CITY PLAN COMMISSION REPORT

The Enclave at Twin Creeks

12 CD-CPC-2022-00003
Development Plan
(w/preliminary plat)

Plan Conditions, Corrections, & Recommendations Report

PRELIMINARY PLAT THE ENCLAVE AT TWIN CREEKS Lot 1 and Tract A-D

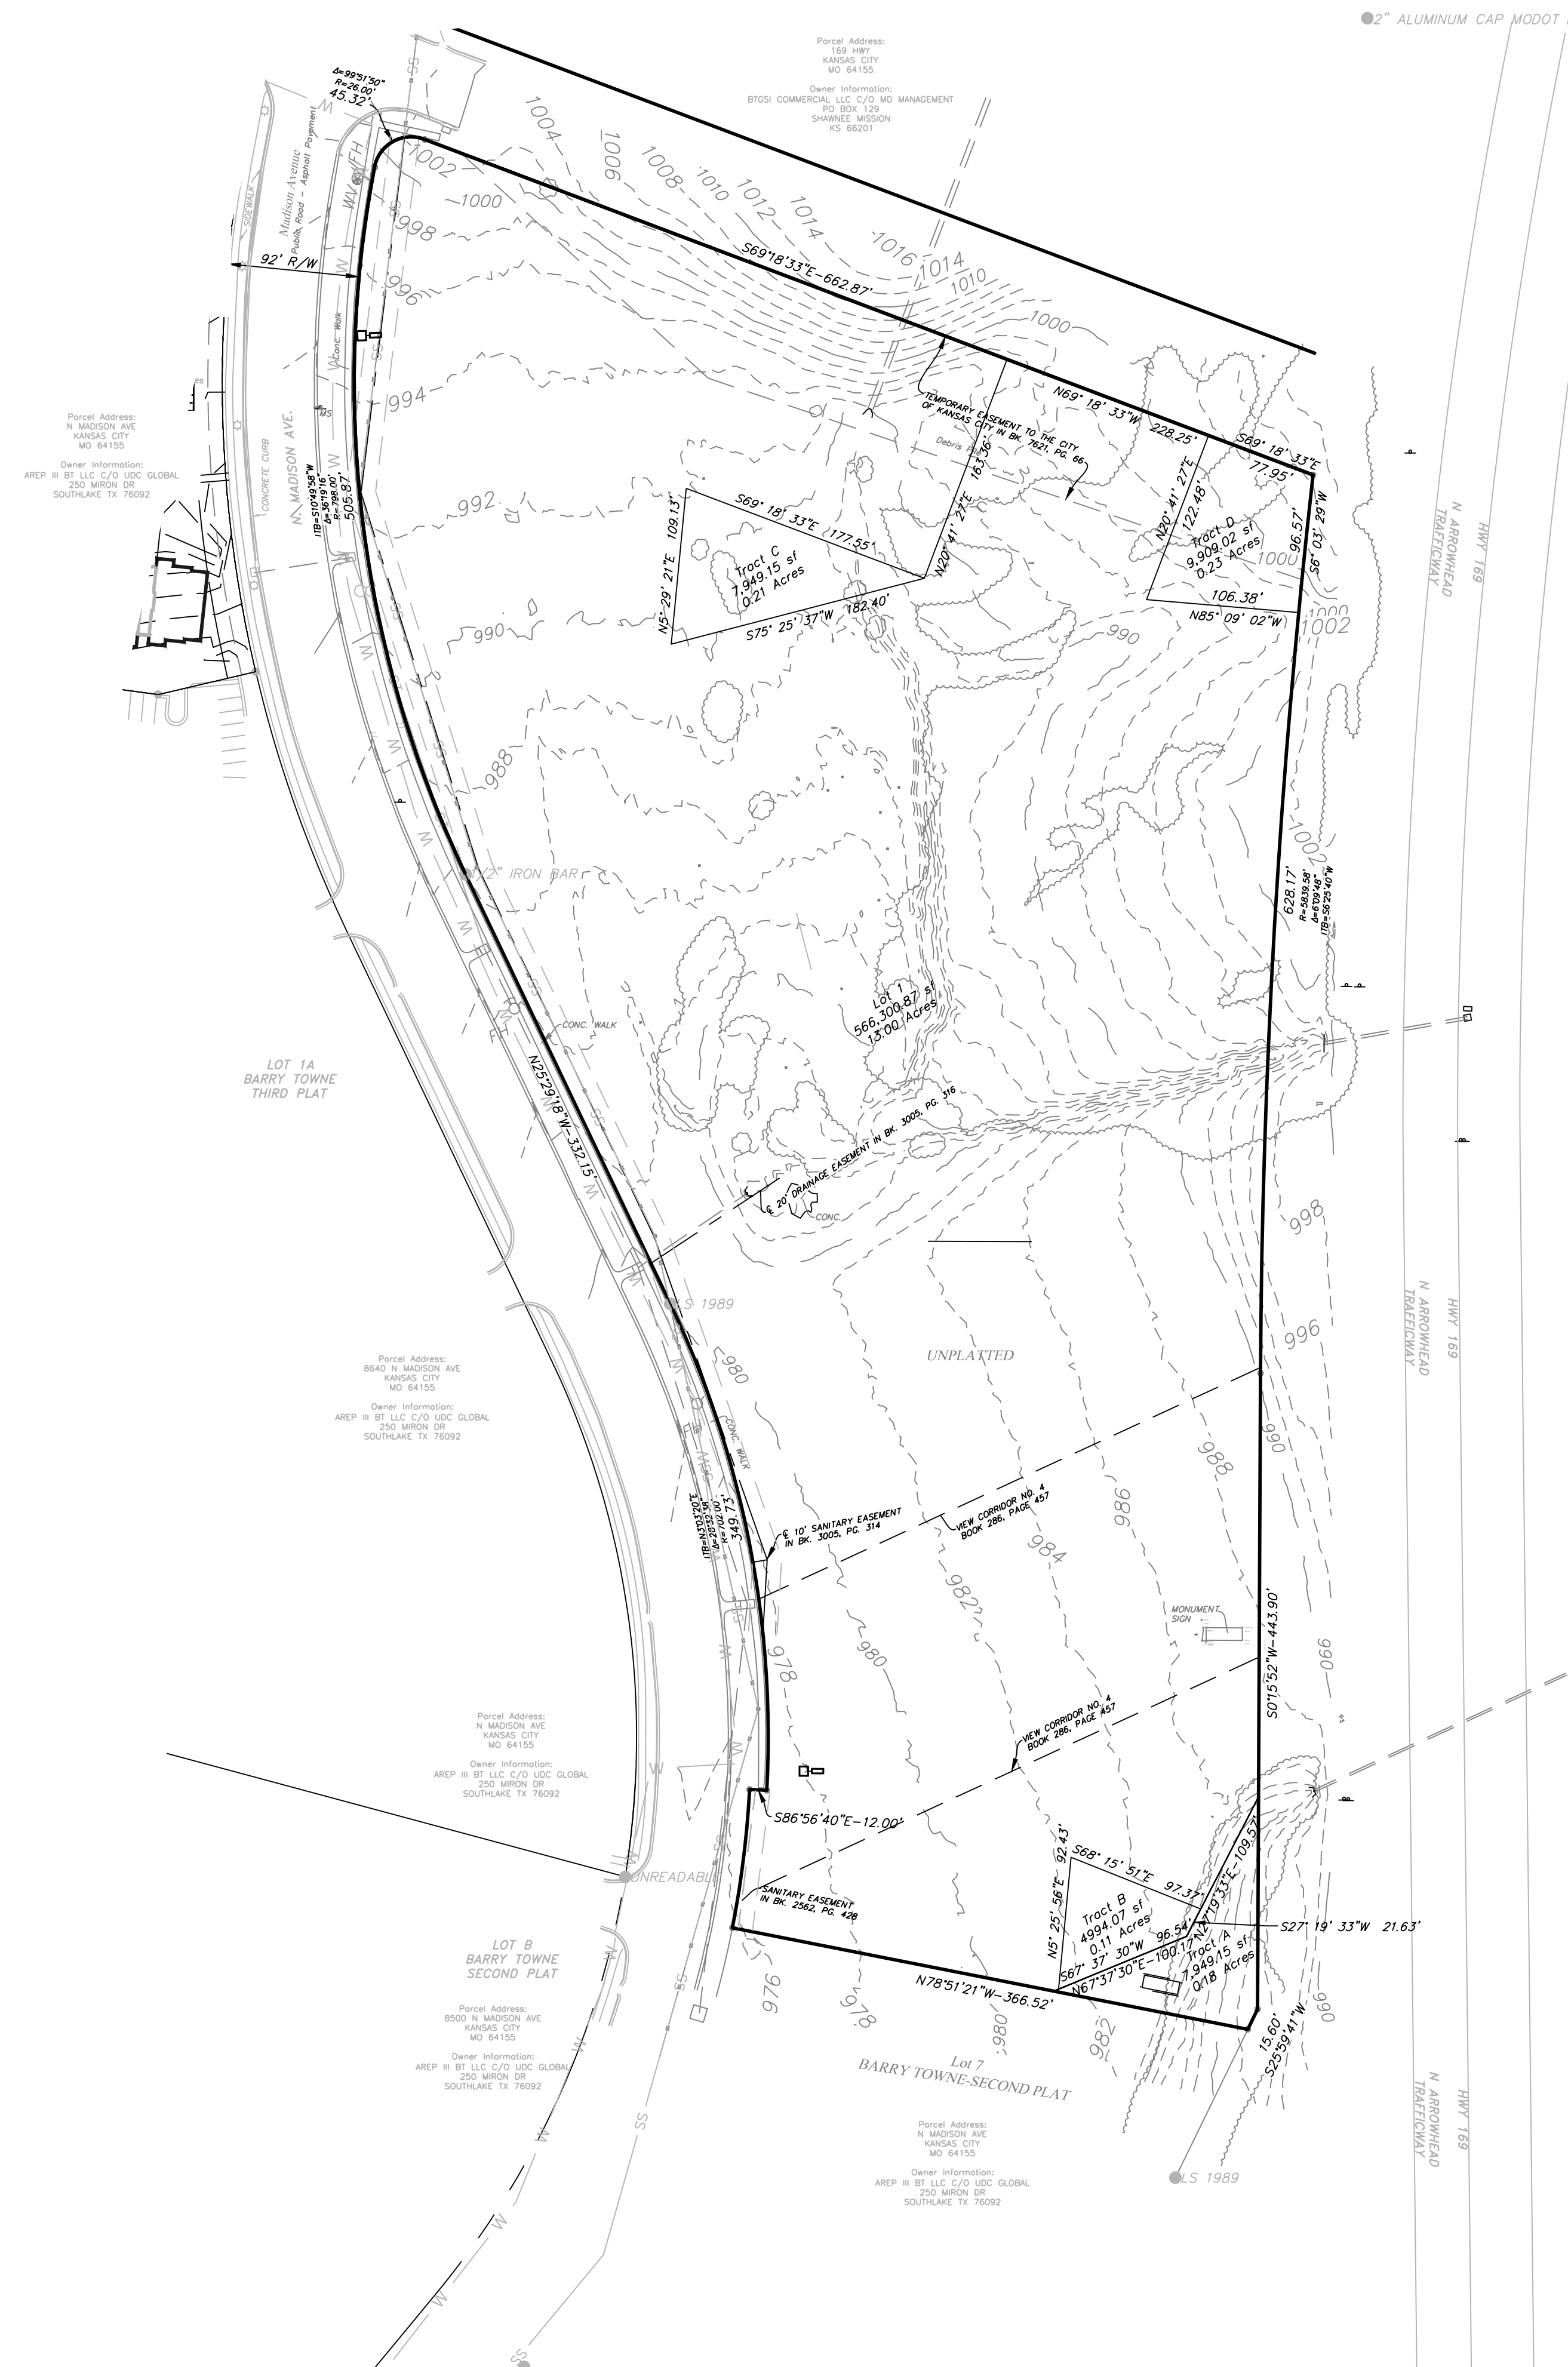
11. The applicant shall make the following changes prior to request for ordinance:
 - a. Change the name of the private tracts listed on the site plan for the playground and the dog park to match the names shown on the preliminary plat.
 - b. Revise the site plan to show pedestrian crossing from nearby houses to the playground.
 - c. Revised the elevation to show board & batten siding for the entire second floor on the rear façade. (2/17/2022)

LANDSCAPE PLAN
SCALE: 1" = 60'

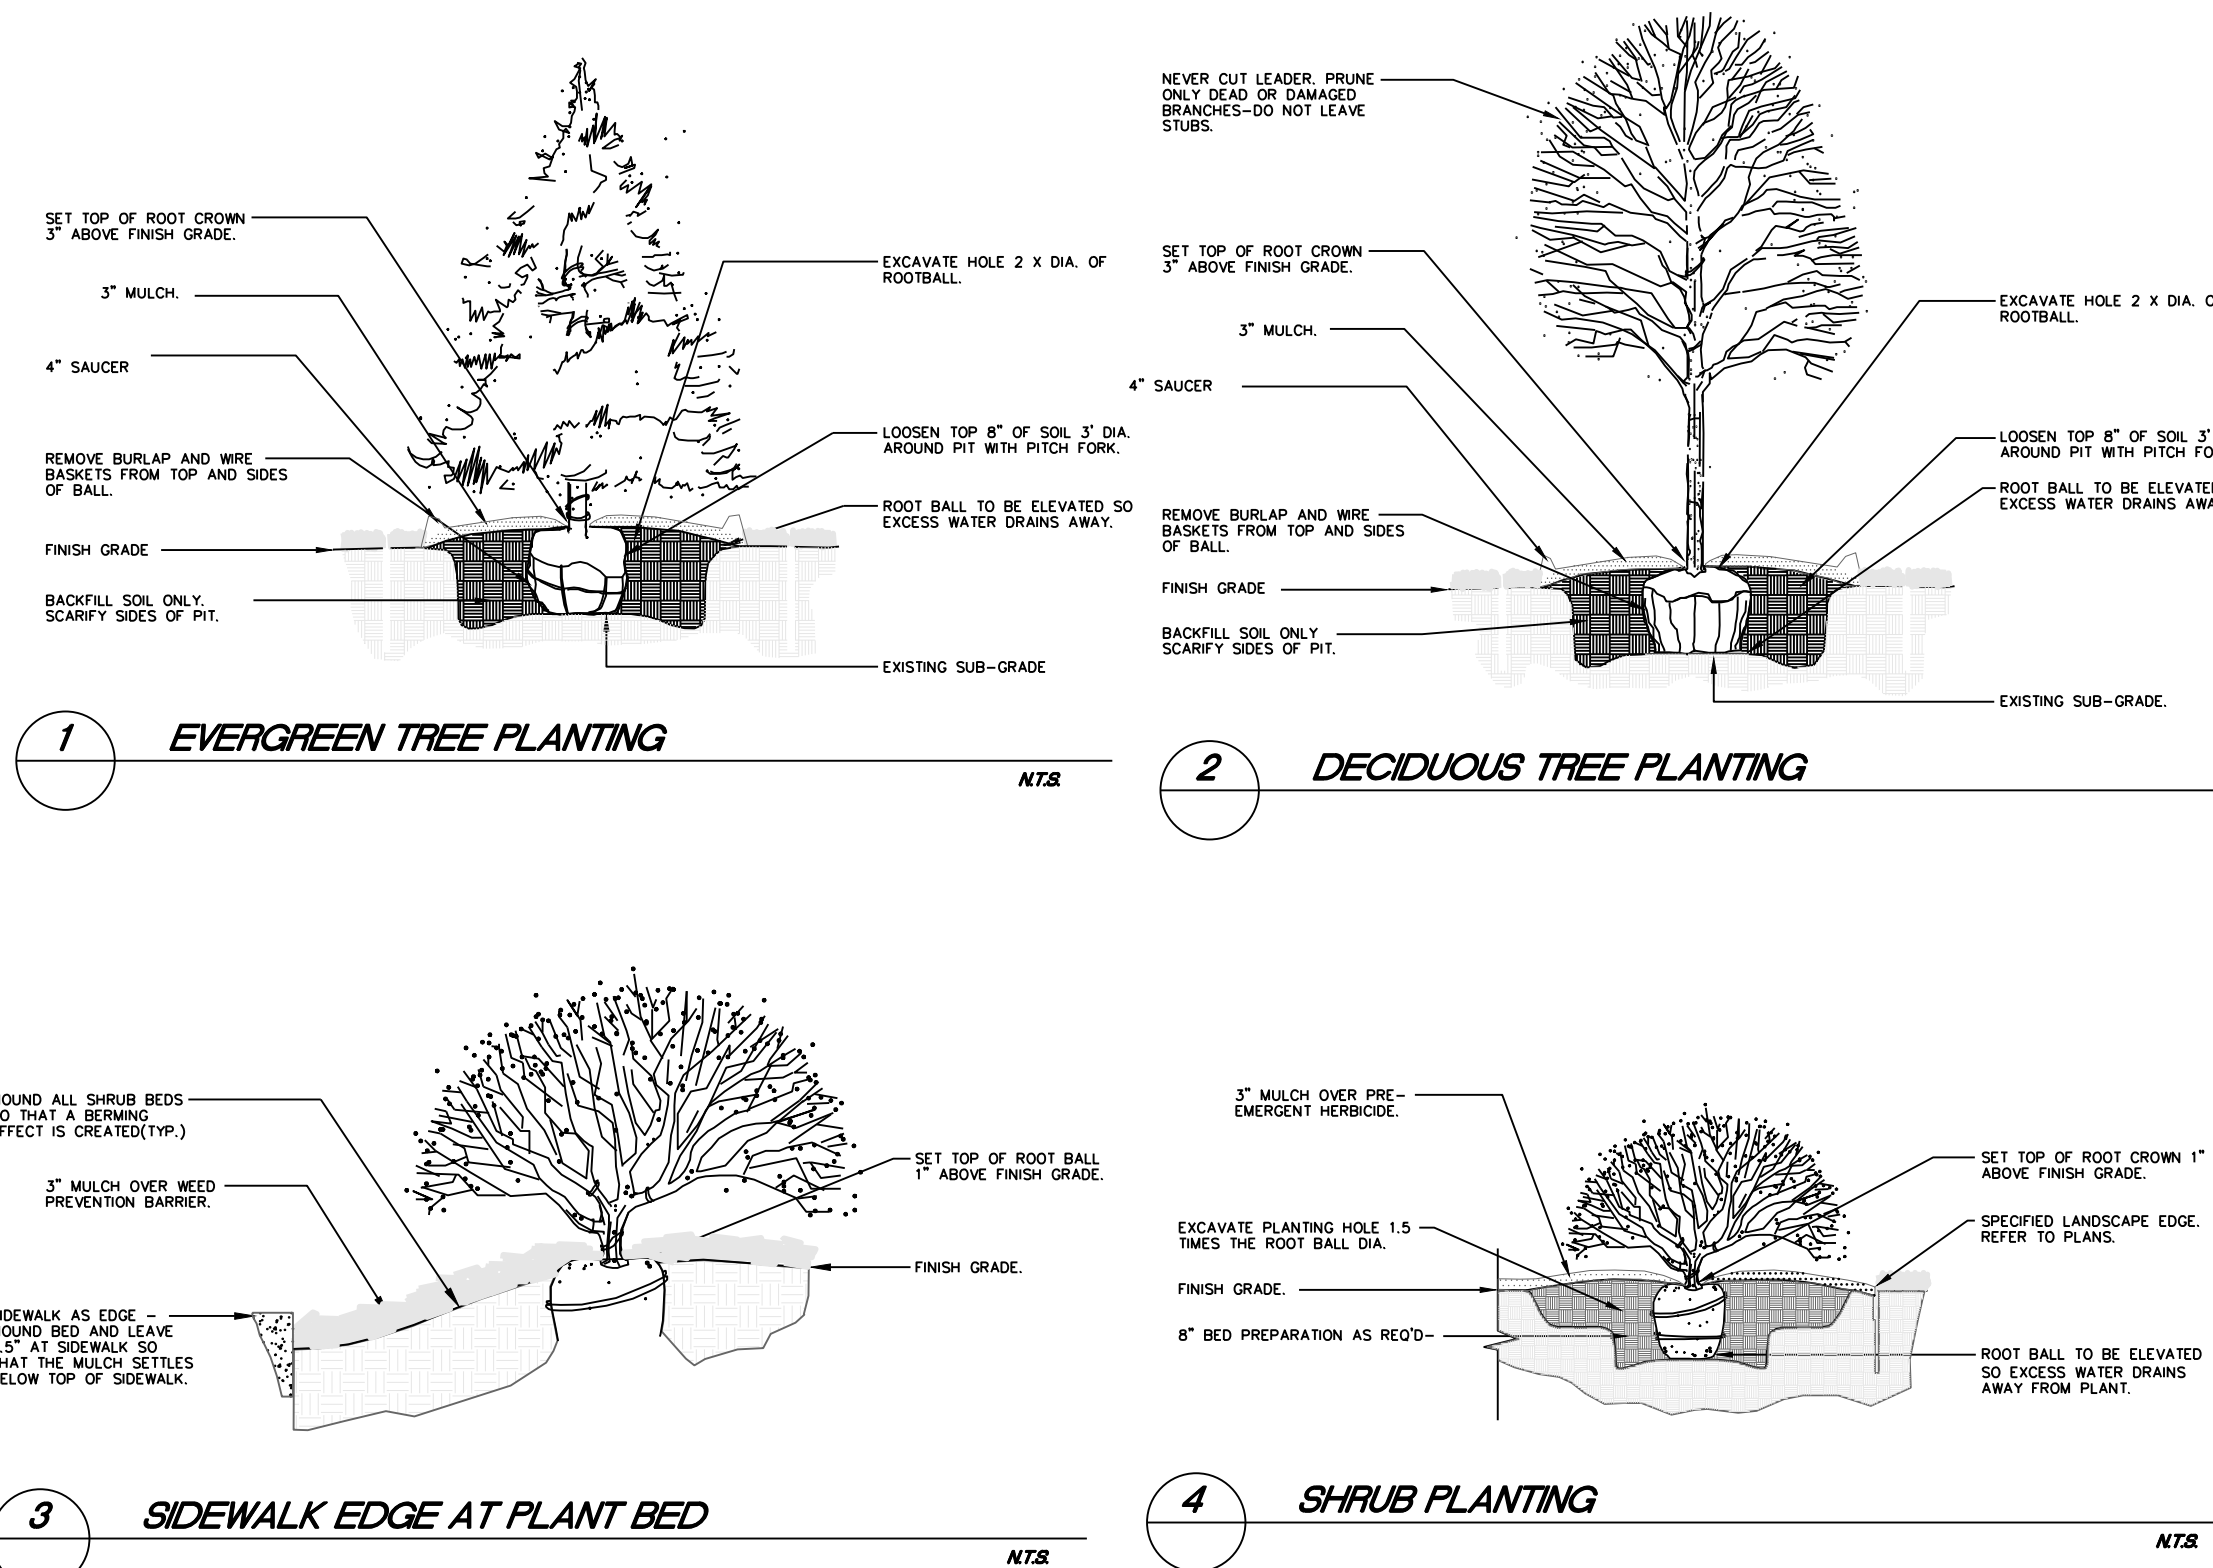
A landscape plan was submitted by the applicant indicating a total of 82 street trees, 86 interior trees and 29 shrubs will be provided. The proposed plan generally complies with the code requirement and staff has recommended improving landscape around the community amenities. The applicant has proposed a residential entrance monument sign abutting Madison. This signage complies with the code.
